GEM TN-92-143

Calorimeter Group Meeting - SSCL

Responses to Questions
Regarding Engineering Issues
of the
GEM Nobel Liquid Calorimetry Options

5 August, 1992

Figure 1-1

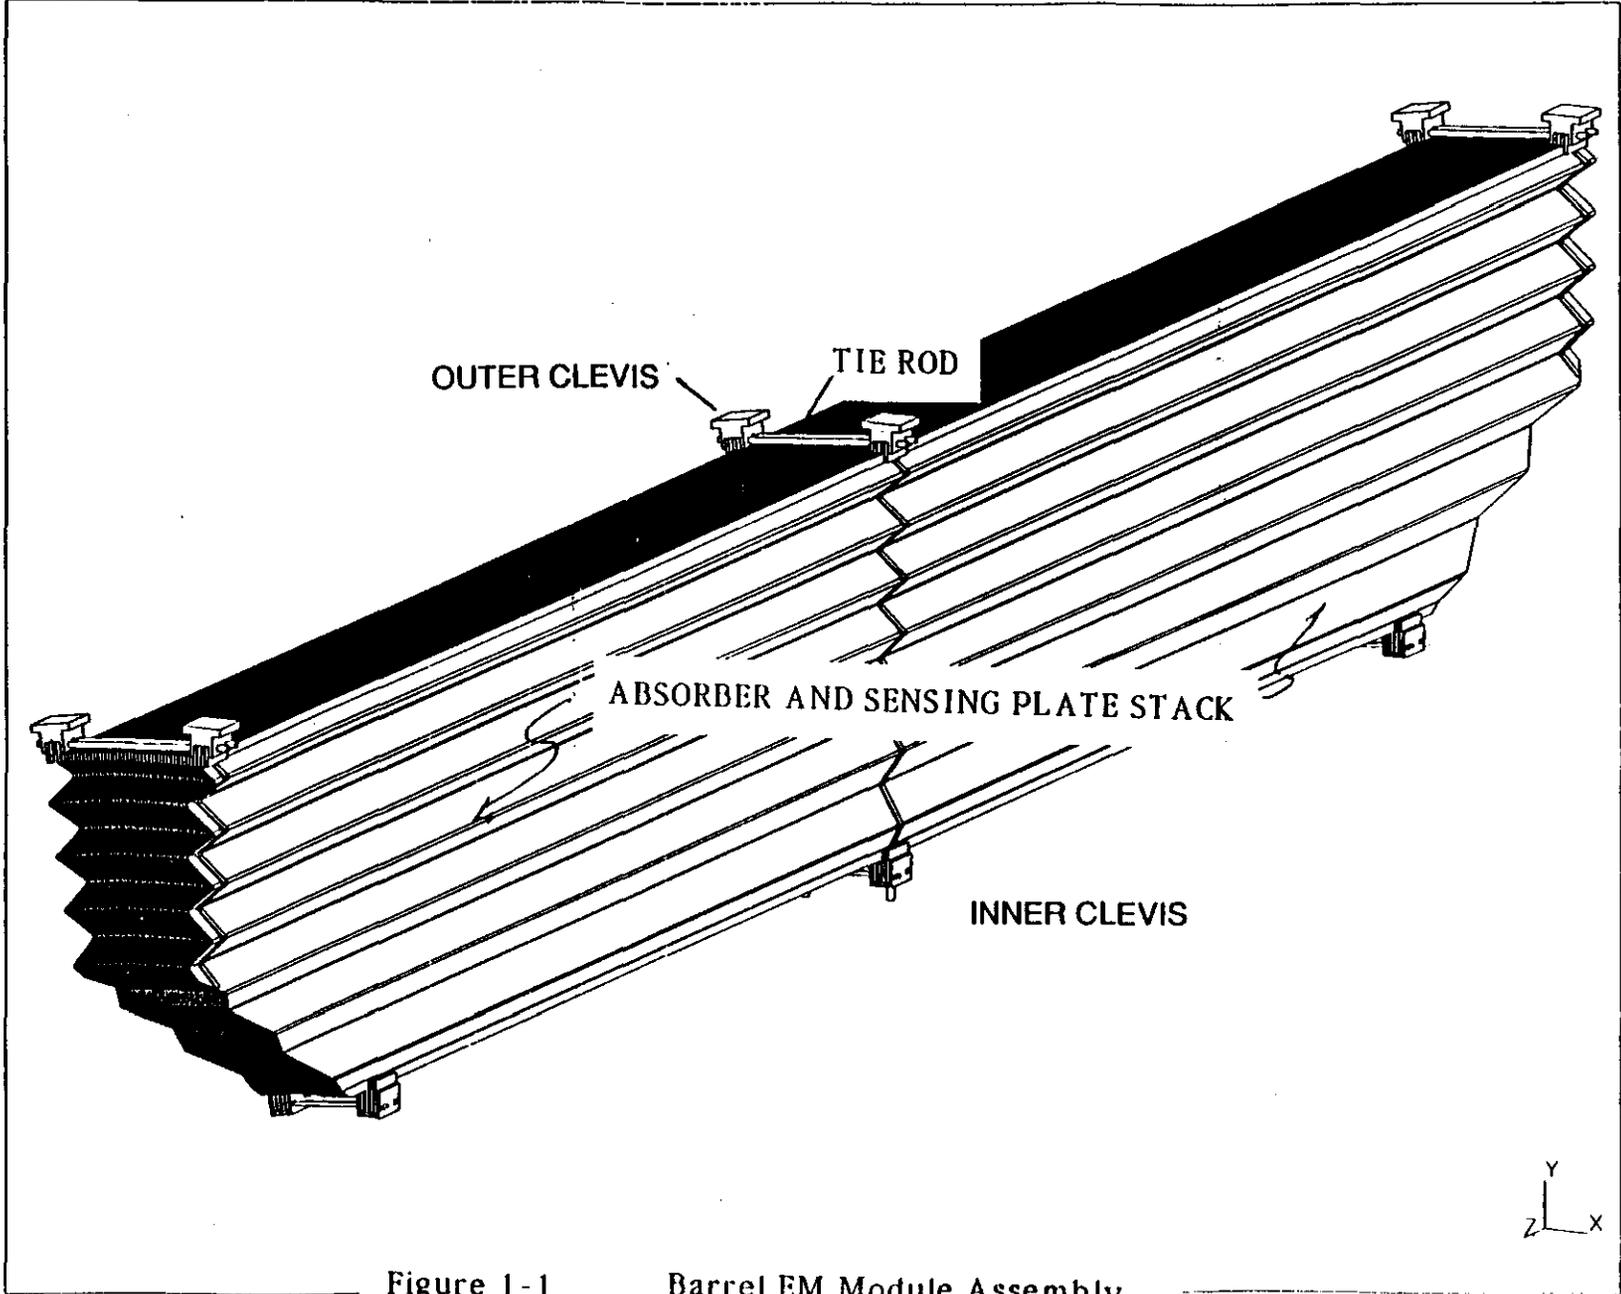
Request: Provide proof-of-principal structural designs for the barrel and endcap accordion EM calorimeters.

- The structure of the individual barrel EM modules prior to assembly is not understood. The module structure will have to be capable of not only supporting the module during handling and shipping; but, it will be required to provide for the transfer of the load to the final assembly structure.

pinned together at the inner and outer radii through the plates and spacer bars and held with fasteners to form a module (reference Figure 1-1).

Figure 1-17 Endcap Accordion EM Without Support System

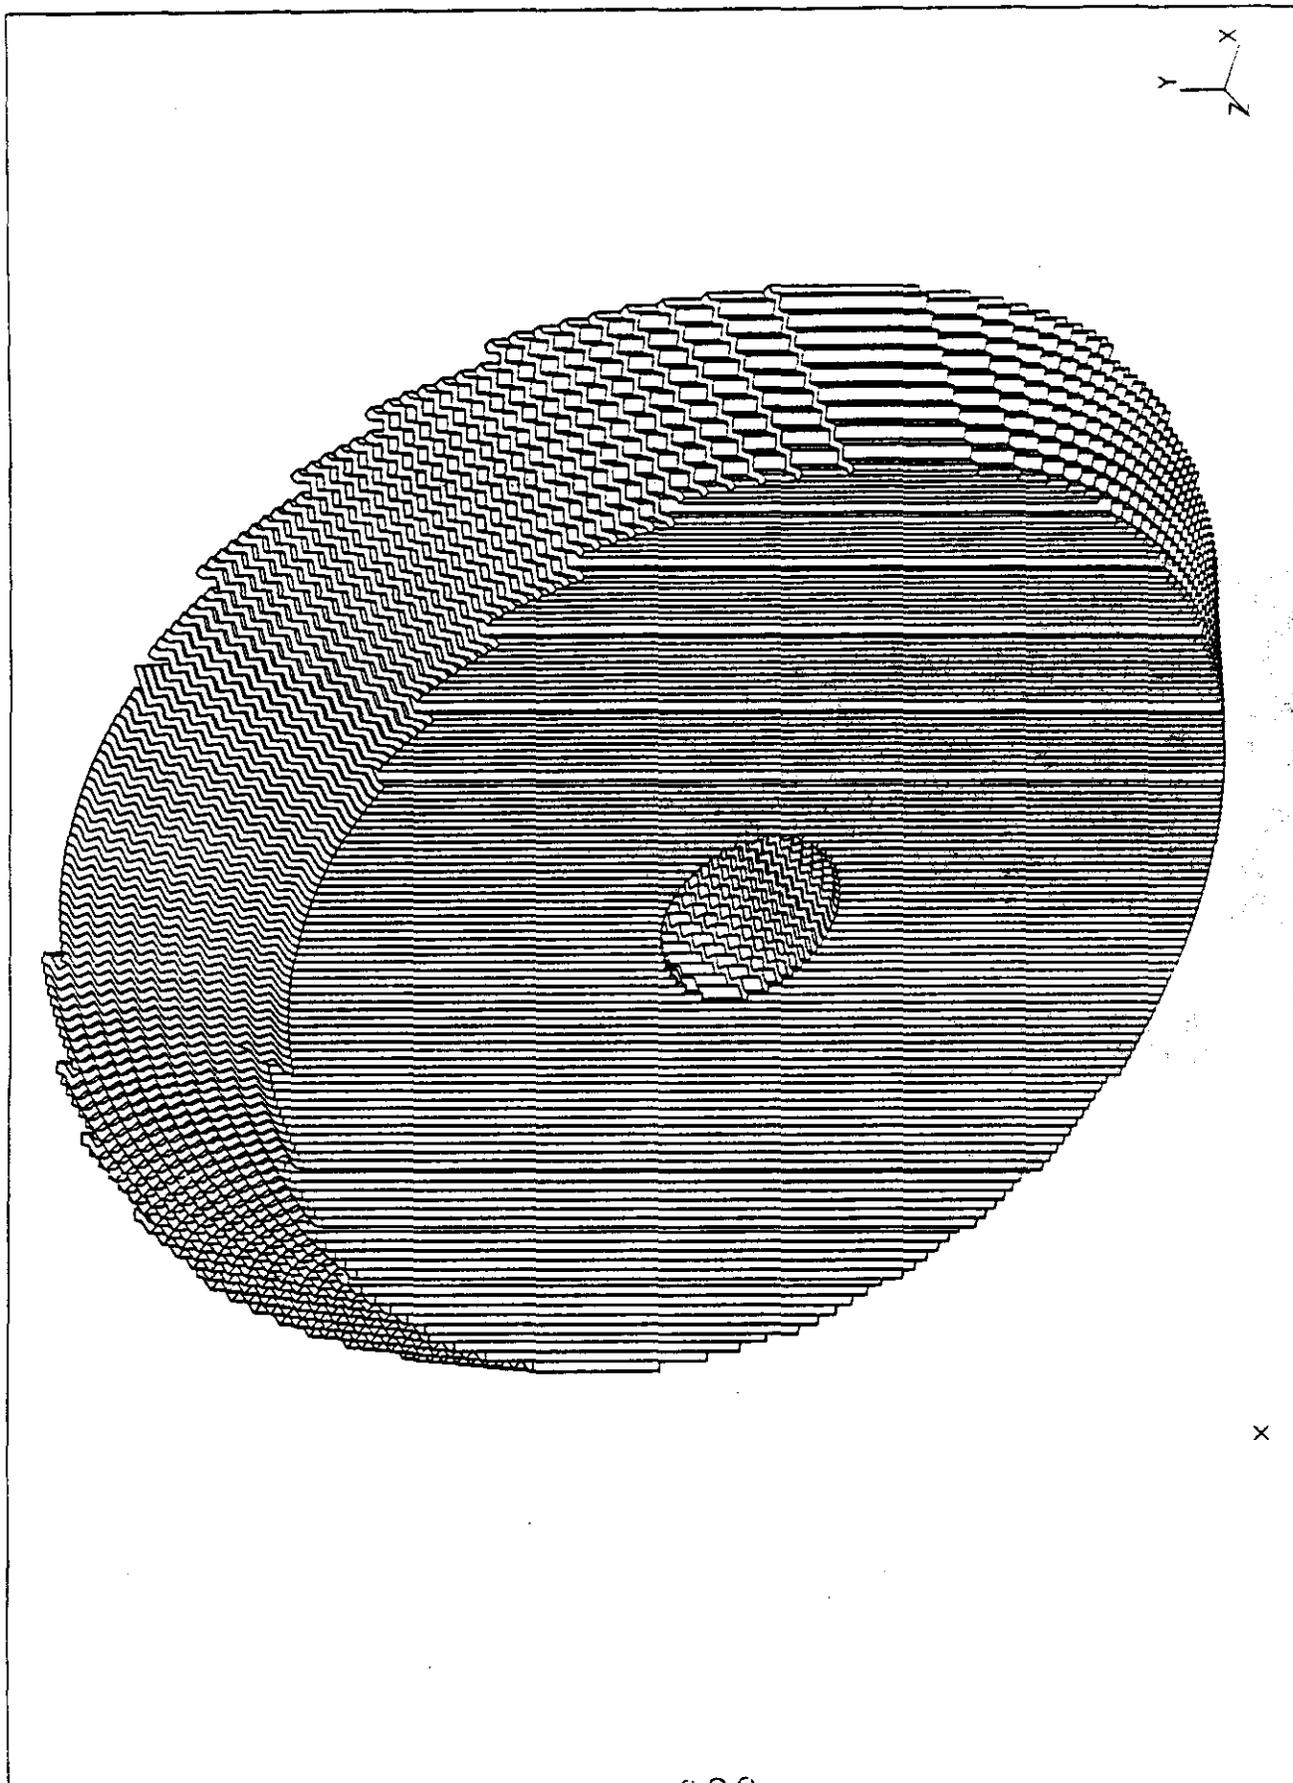
Request: Provide a proof-of-principal structural designs for the barrel and endcap accordion EM calorimeters.

The Endcap accordion EM is constructed of 330 sensor and 331 absorber plates grouped into 110 physical "towers" (reference Figure 1-17). The first and last bend of each plate project to interaction point (reference Figure 1-18). G10 spacers are placed between the plates to provide the proper spacing of the plates. The plates are held together with fasteners. Hexcel strips are placed in the accordion region to provide a minimum high voltage gap between the sensor plate and the absorber plate. At appropriate locations the accordion is shifted one cycle to compensate for the curvature of the accordion structure. Each of these shifts contains a G10 stiffener as the structural element that supports the weight of many plates and provides a stiff support to control the effects of thermal shrinkage. The stiffeners are attached to a perforated G10 face plate. Two halves of a conical aluminum shell are joined and the face plates and stiffeners are attached to flanges on the outer edges of the aluminum shell (reference Figures 1-19, 1-20, 1-21). The flange on the rear outer edge of the aluminum shell is also used to attach the EM assembly to Endcap Calorimeter stay.

Figure 2-1. Vessel Dimensions Ambient and Cold

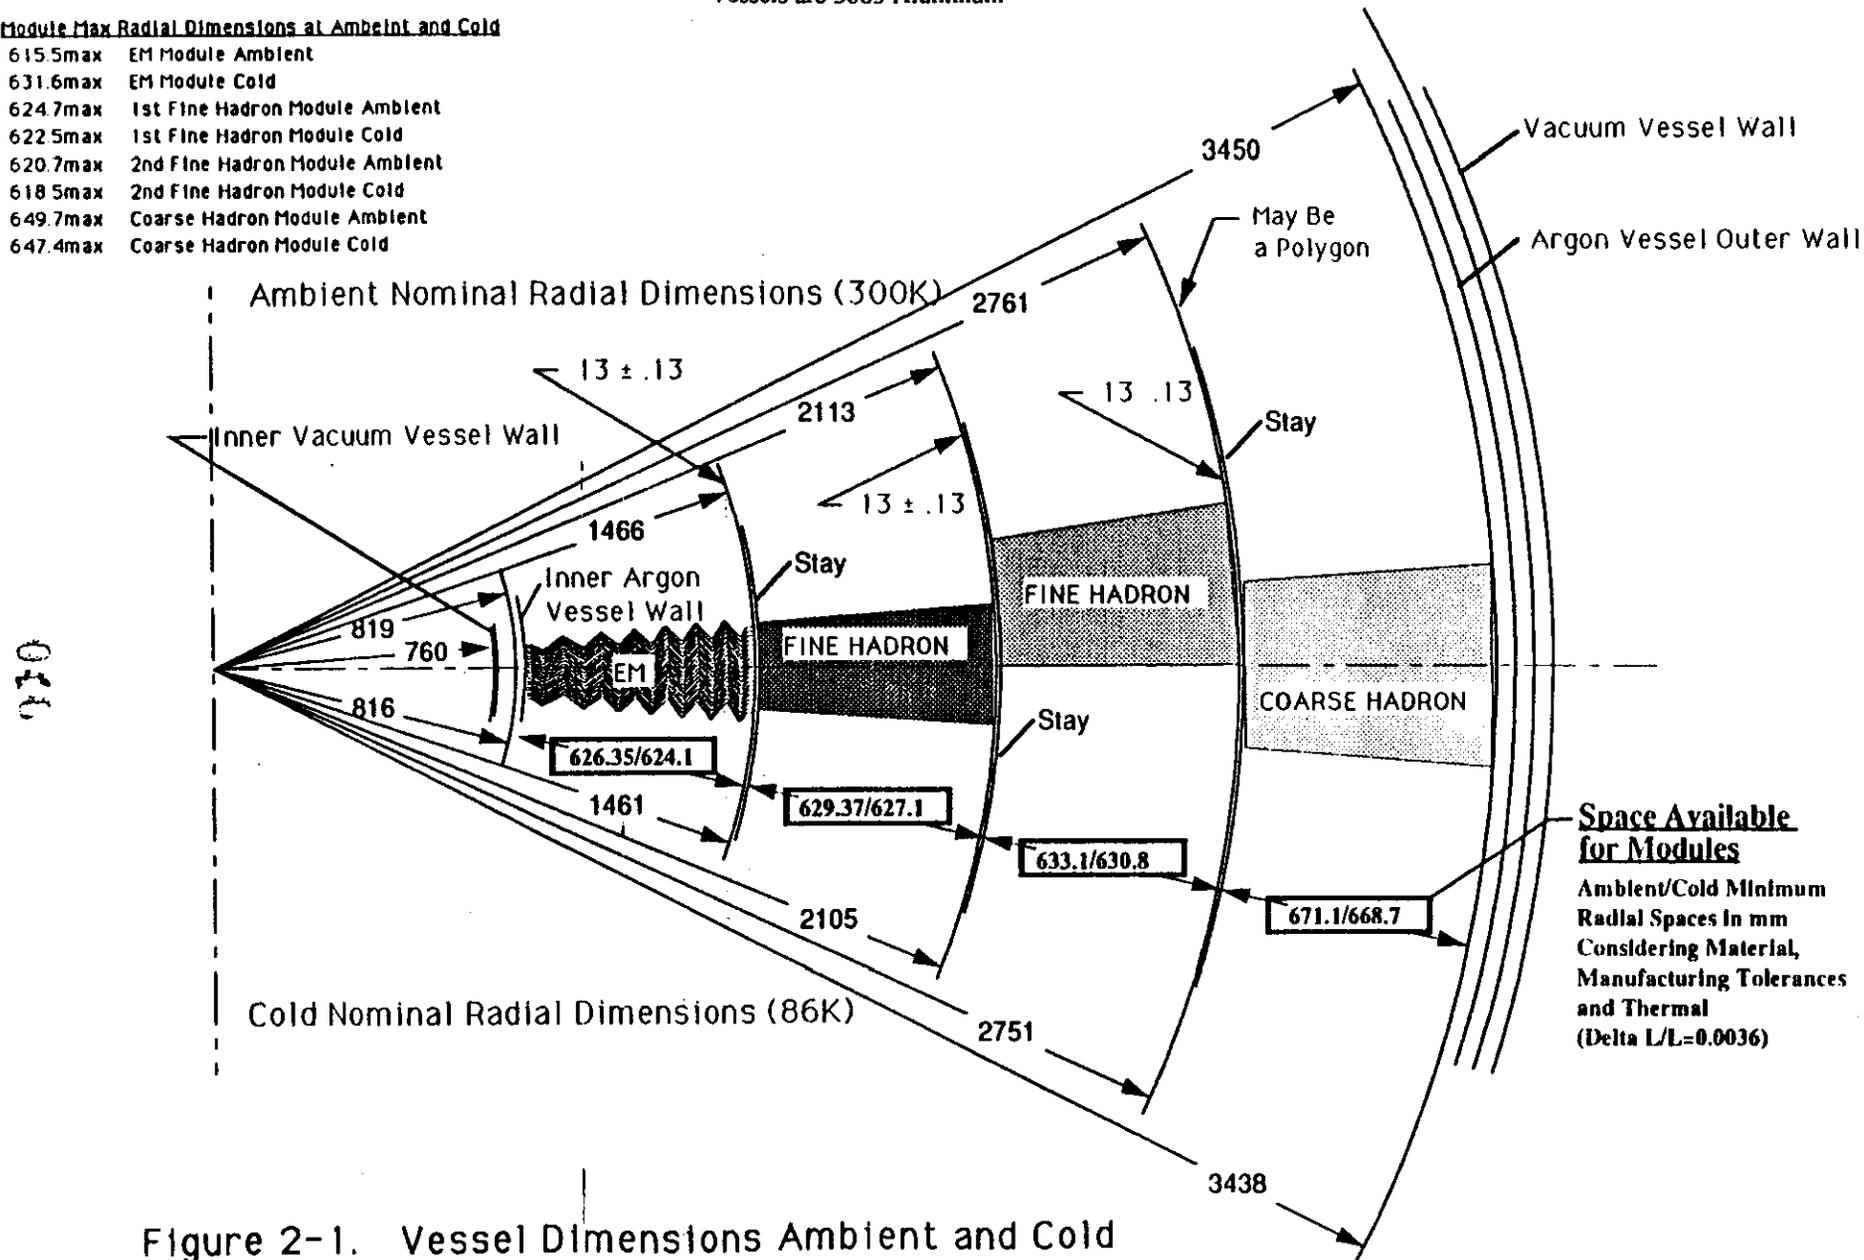
Request: Provide a more detailed tabulation of the diametrical stack-up of the integrated liquid argon calorimeter.

- *See Figure 2-1.*

Figure 2-1. Shows the nominal vessel wall and stays as fabricated. The minimal fabricate radial spaces for modules are show for comparison with the maximum module sizes. Both sets of dimensions are also shown for a temperature of 86K.

Figure 3-1 Plan View of Liquid Argon Calorimeter Showing Stanchion Locations

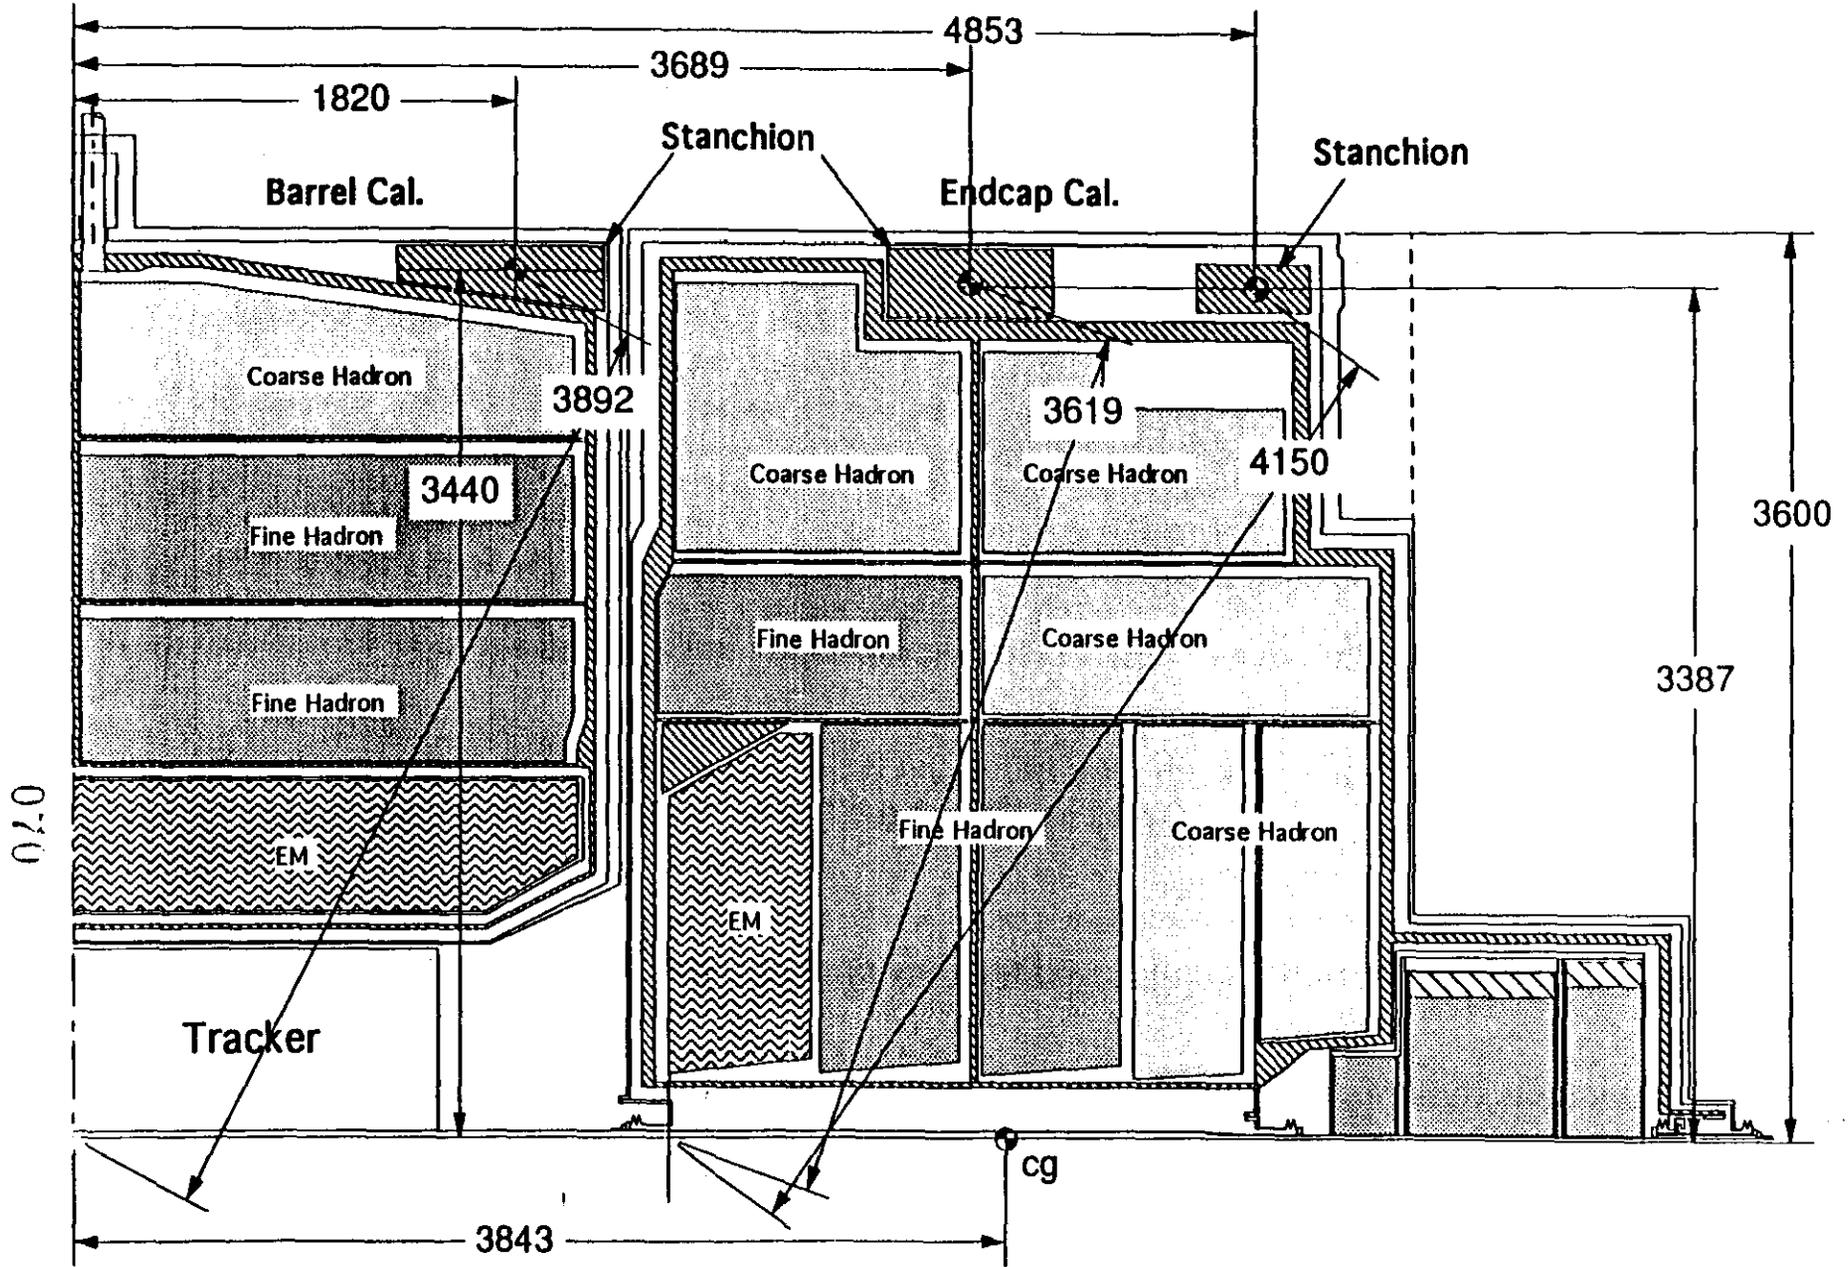
Request: Provide a scaled end section view of the liquid argon vessel cold mass supports.

- Plan and end views of the liquid argon vessel showing the locations of the stanchions (cold mass supports) are given in Figures 3-1 & 3-2, respectively.
